City of Kerrville Planning & Zoning Commission Agenda

Thursday, February 7, 2008 4:30 p.m.*

5A. Residential Replat: Saddlewood Estates, Section Two – A replat to combine Lots 3 and 4, Block Ten, Saddlewood Estates, Section Two into one (1) lot located at 2526 and 2586 Saddlewood Blvd. Zoned: ETJ. Applicant: Grogan Surveying. (File No. 2007-61)

5B. Thoroughfare Plan Amendment – Consider a recommendation to the City Council to amend the Thoroughfare Plan (Link 4, Kerrville Comprehensive Plan) to remove the proposed collector road between Spur 100 and Creekwood Road. Applicant: Voelkel Engineering and Surveying. (File No. 2008-02)

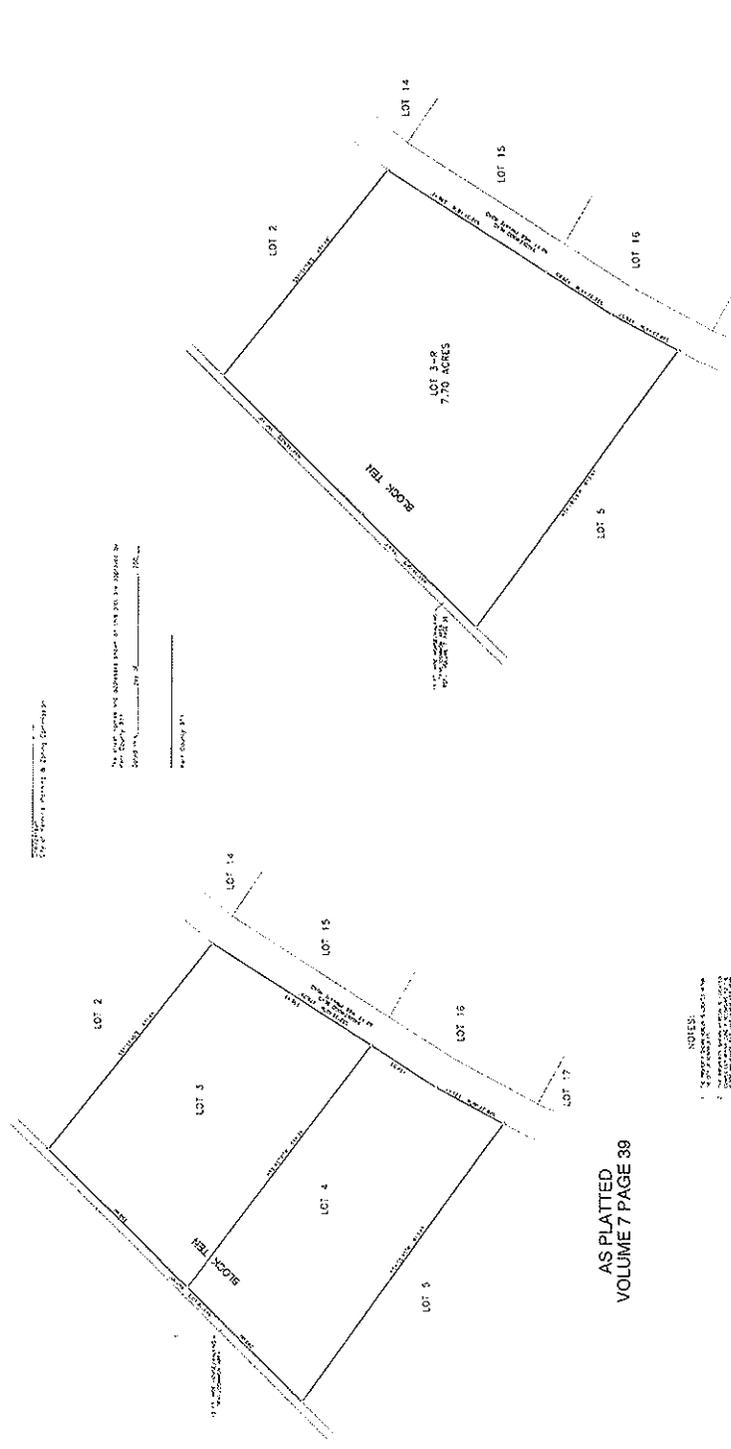
In addition to consideration of the replat, the applicant is requesting that the Commission consider variances to the Subdivision Regulations regarding the requirements of two (2) subdivision corners set to the State Plane Coordinate System and one (1) corner located with respect to a corner of the original survey. The section from the Subdivision Regulations addressing these requirements and a memo from Kerr Central Appraisal District are attached for your review.

Both of these requirements are used by the City and other entities in the County to digitally rectify plats and replats into their respective geo data bases. Staff recommends that the Commission deny the applicants request.

1. Open the public hearing and receive comments,
2. Deny the variance requests as submitted, and
3. Approve the replat subject to, a). The inclusion of two (2) subdivision corners set to the State Plane Coordinate System and b). At least one (1) corner of the subdivision located with respect to a corner of the original survey of which it is a part.

**Figure 4.1
Thoroughfare Plan**

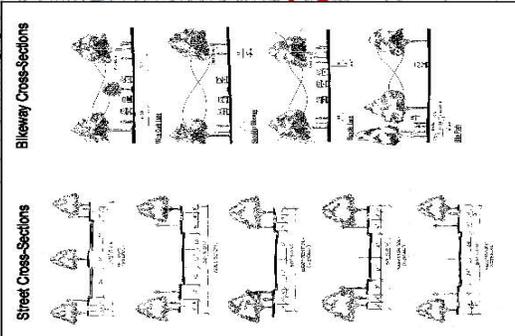
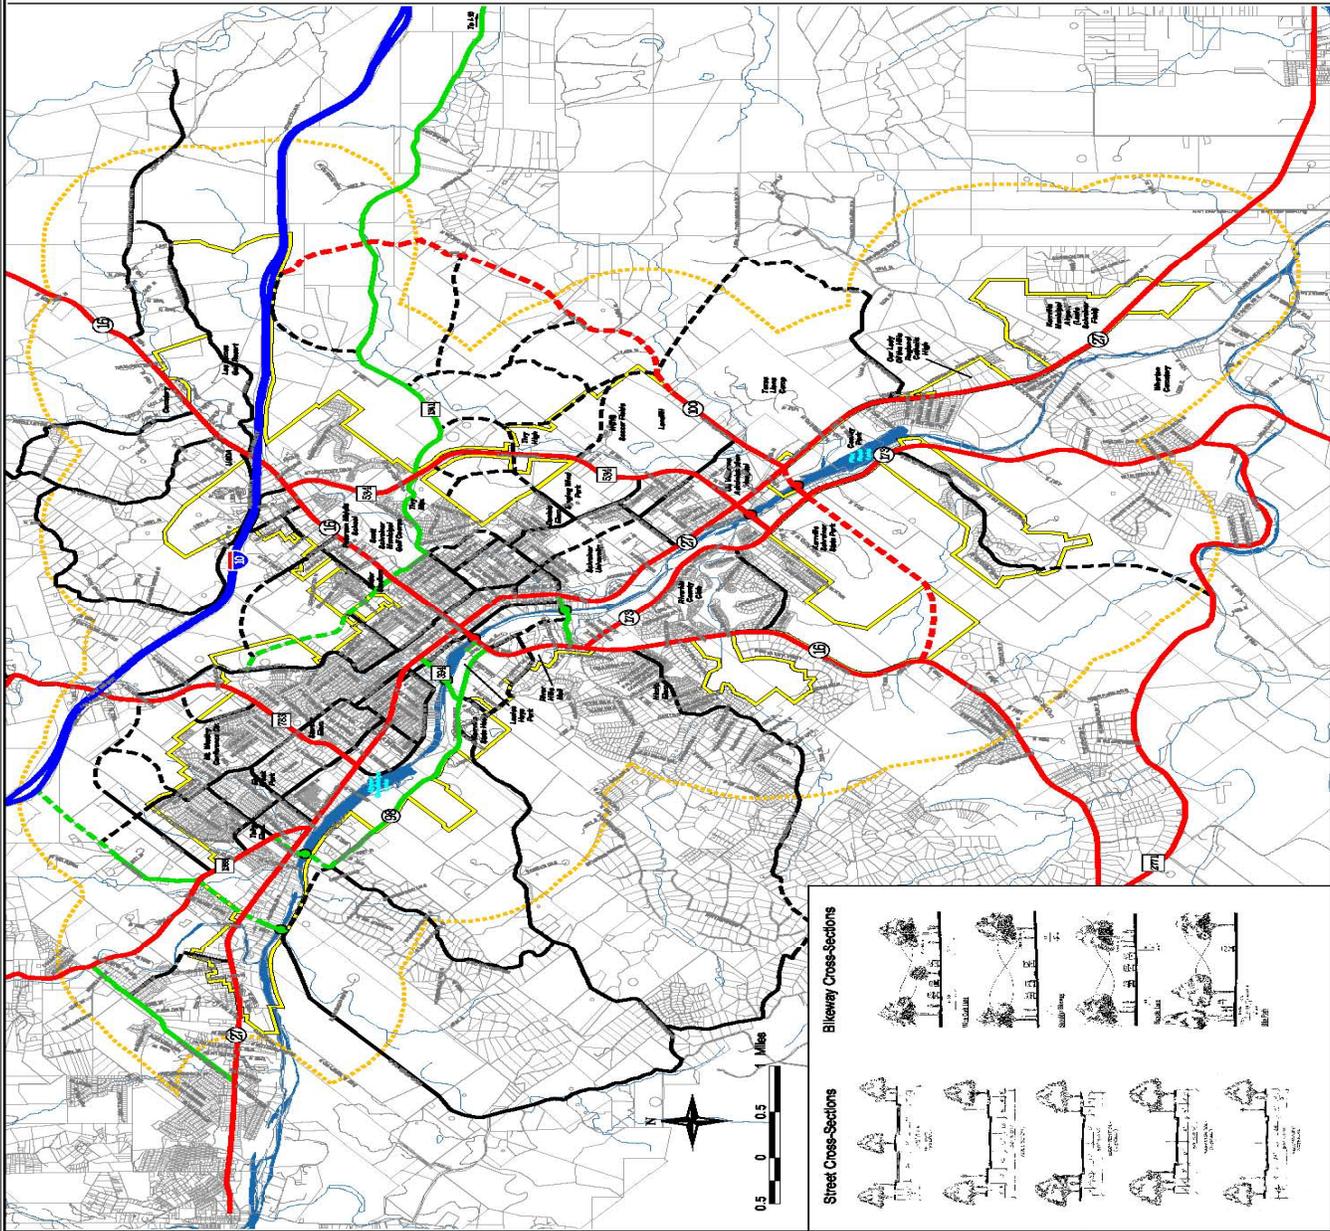
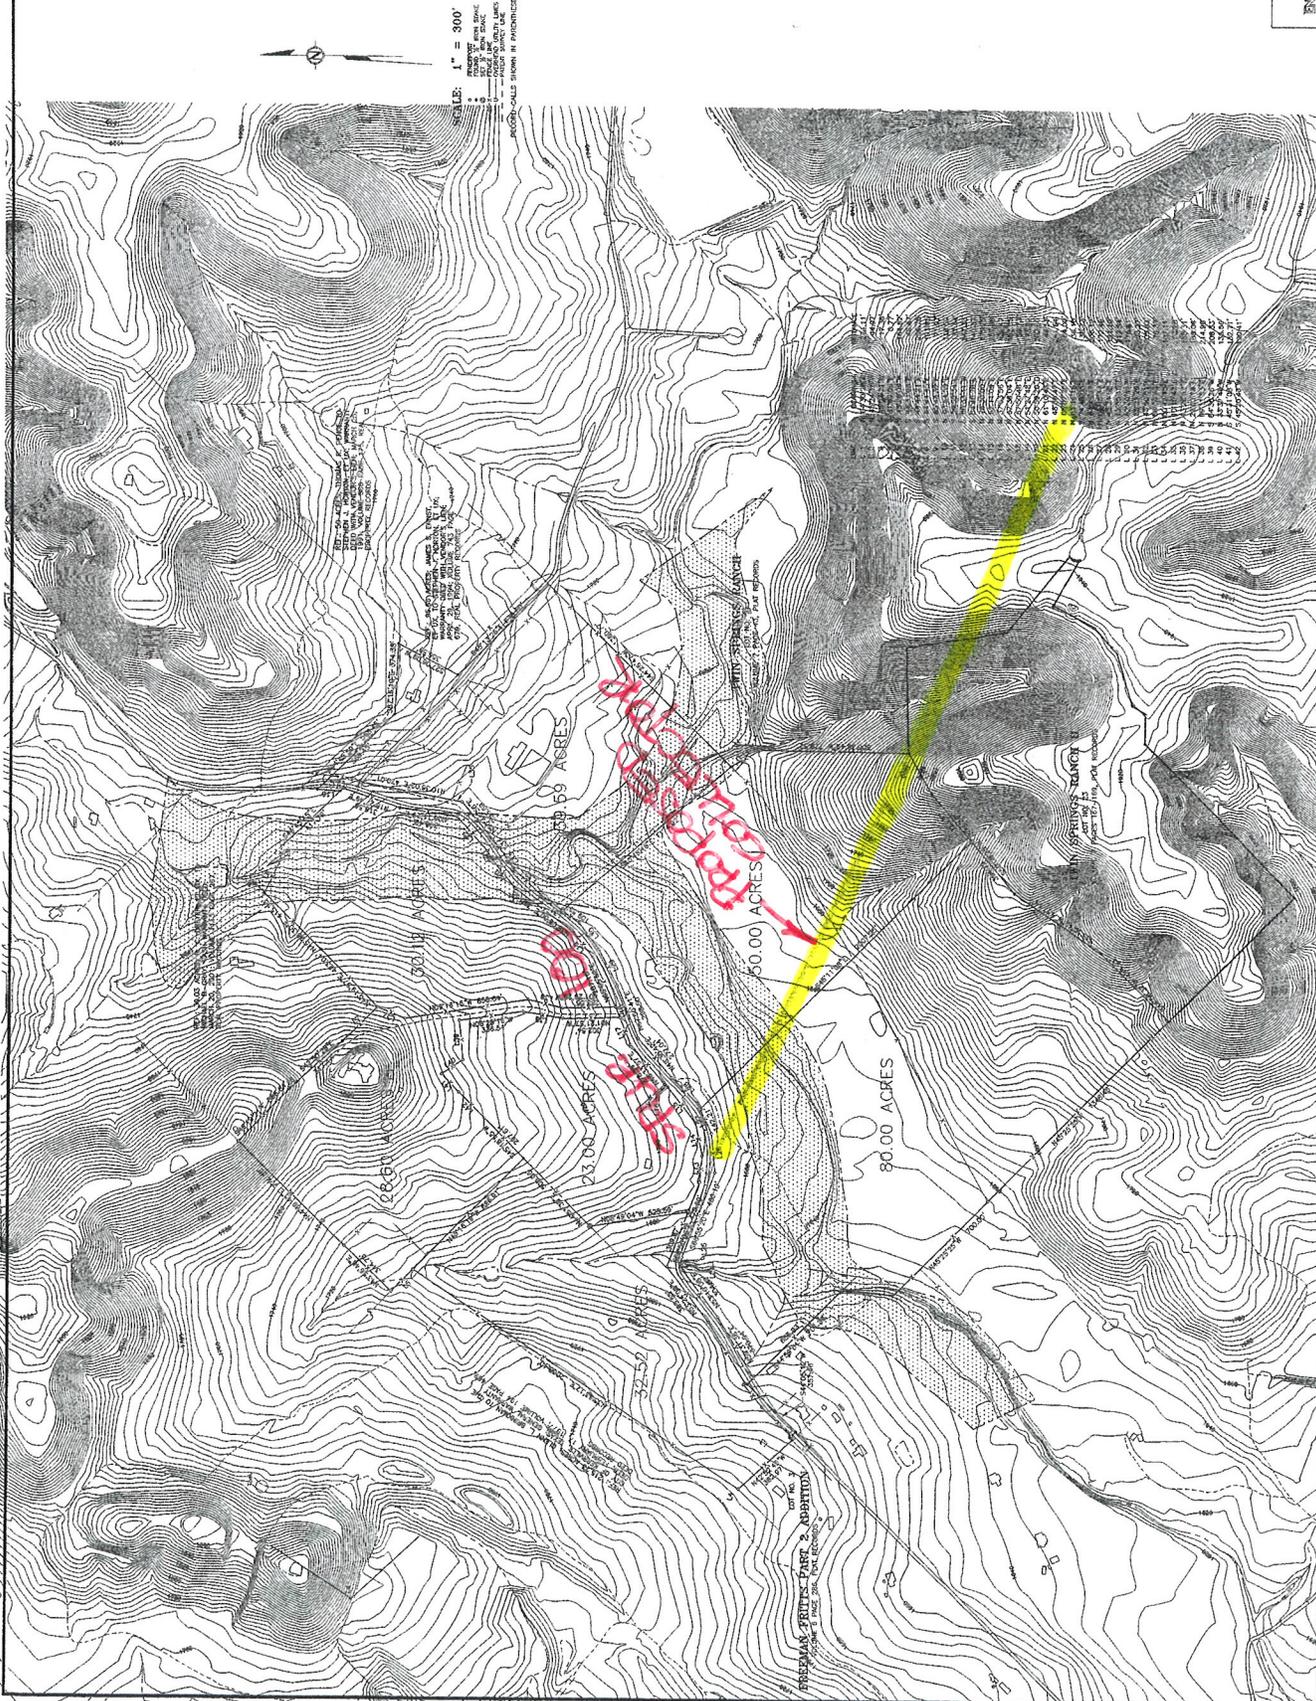
Thoroughfare Plan as it relates to a collector road extension between Spur 100 and Creekwood Road. In his request, see letter dated January 11, 2008, the applicant lists the following to justify his request, 1). The proposed roadway crosses developed large lot subdivisions, Twin Springs Ranch and Creekwood with minimum lot sizes of twenty-five (25) acres, 2). Both Twin Springs Ranch and Creekwood are private restricted developments served by privately maintained roads, 3). The density of the area as currently developed does not justify a collector road in this area, 4). The topography of the area is such that the area is not economically feasible to build a collector road, and 5). Due to the topography the grade of the road would exceed the maximum road grade allowed.

Staff has reviewed the request made by the applicant, his justification for removing this road segment from the Thoroughfare Plan and a future need of a connection from the Creekwood Road/Twin Springs Road area to the proposed extension of Spur 100. While no removal or alteration of any roadway proposal shown on the Thoroughfare Plan should be considered without a detailed alignment study, staff requests that the following recommendation be considered by the Commission;

1. That the applicants request be modified to include only that portion of the collector road from the Creekwood Road/Twin Springs Road area to Spur 100, and
2. That further evaluation of the Thoroughfare Plan in the existing ETJ and the future 2-mile ETJ reflect the existing topography as well as land use.

1. Open the public hearing and receive comments, and
2. Recommend to the City Council the elimination of the proposed 'collector road' shown on the Thoroughfare Plan from the Creekwood Road/Twin Springs Road area to Spur 100, as shown on the attached exhibit, and development of an ordinance so amending the Thoroughfare Plan.
